SYDNEY SOUTH PLANNING PANEL

Panel Ref No.	2016SYE070
DA Number	DA-104/2016
Local Government Area	City of Canterbury-Bankstown
Proposed Development	Demolition of all existing structures and construction of an Infill Affordable Housing development totalling 19 multi dwellings with associated landscaping and basement parking.
Street Address	47, 49 & 51 Chapel Street, Roselands (Lot 30 DP 555773, Lot 40 DP 561045 & Lot 5 DP 37301)
Applicant / Owner	Mssrs J & P Katerinis, C/- Minto Planning Pty Ltd V & M Halias
Number of Submissions	2 submissions received
Recommendation	Refusal
Report by	Shona Porter – Development Assessment Officer

Supplementary Assessment Report

Figure 1: Extent of excavation shown bolded **Source:** McCullum Ashby Architects

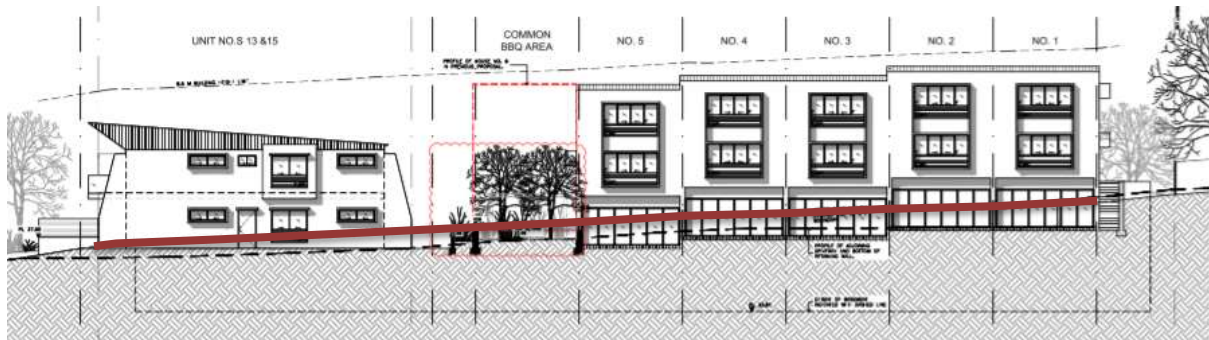
The proposed scheme seeks extensive excavation of the site, particularly the northern row of three storey dwellings. Irrespective of the basement level with associated laundry/storage/gym areas as nominated on the plans, the ground floor living areas have been buried into the ground to accommodate over half the room. This is highlighted as per the North Elevation Plan Dwg A015 Revision H shown below:

A third storey cannot be accommodated without burying the development. Instead, the applicable 8.5m height limit accommodates a two storey built form. The immediate impacts of such extensive excavation of living areas (and the associated private open space), is poor amenity from cold and dark rooms and restricted outlook from the living areas and open space.

Figure 2: East Elevation of the proposed development from Chapel Street **Source:** McCullum Ashby Architects

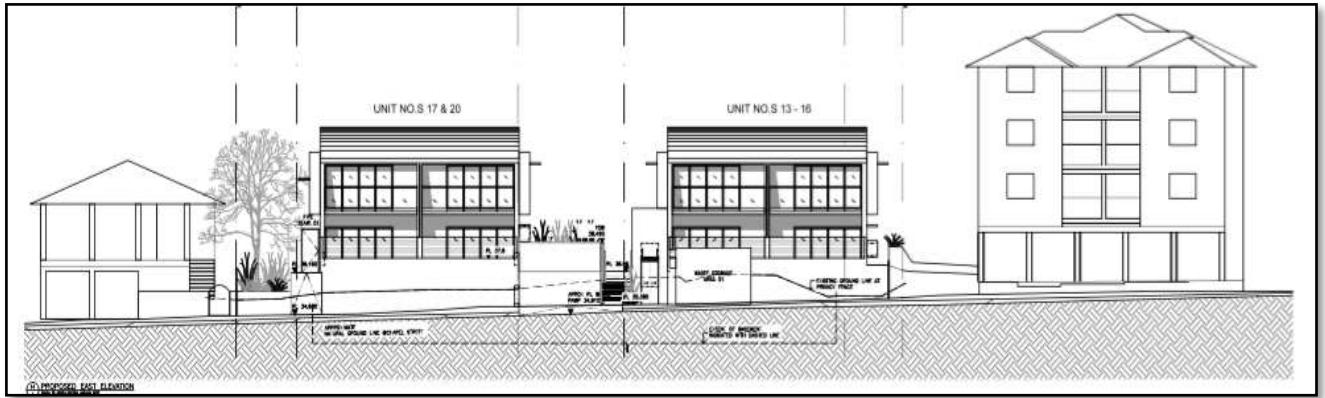
The proposal fails to facilitate safe and visible egress into the ground floor and first floor dwellings fronting Chapel Street. The ground floor entries are all located midway along the side of the dwellings, instead of opening directly onto Chapel Street. The front courtyards of the ground floor dwellings appear significantly raised, as a result of the sloping site conditions to the street. In this respect, the FFL of the courtyard is 36.7 whilst the street kerb is approximately 35.39. The respective elevation of the courtyard is 1.31m, however the effective impact to the street is 2.91m due to the proposed 1.6m privacy screen on the street elevation. The development offers little interaction with the streetscape as should be facilitated by front courtyards. Coupled with the side location of the ground floor entries, the proposal fails to facilitate an effective interface between the private and public domain and creates a sense of separation from the streetscape.

The lack of interaction between the proposed development and the streetscape is shown below:

- Unsafe entryways

Further, the first floor dwellings (fronting Chapel Street) contain rear entryways and do not obtain any passive surveillance opportunities for future occupants from either the street or rear rows of dwellings as described above. The proposal therefore fails to provide safe access into the dwellings as per Part 6.3.1 of the CDCP 2012.
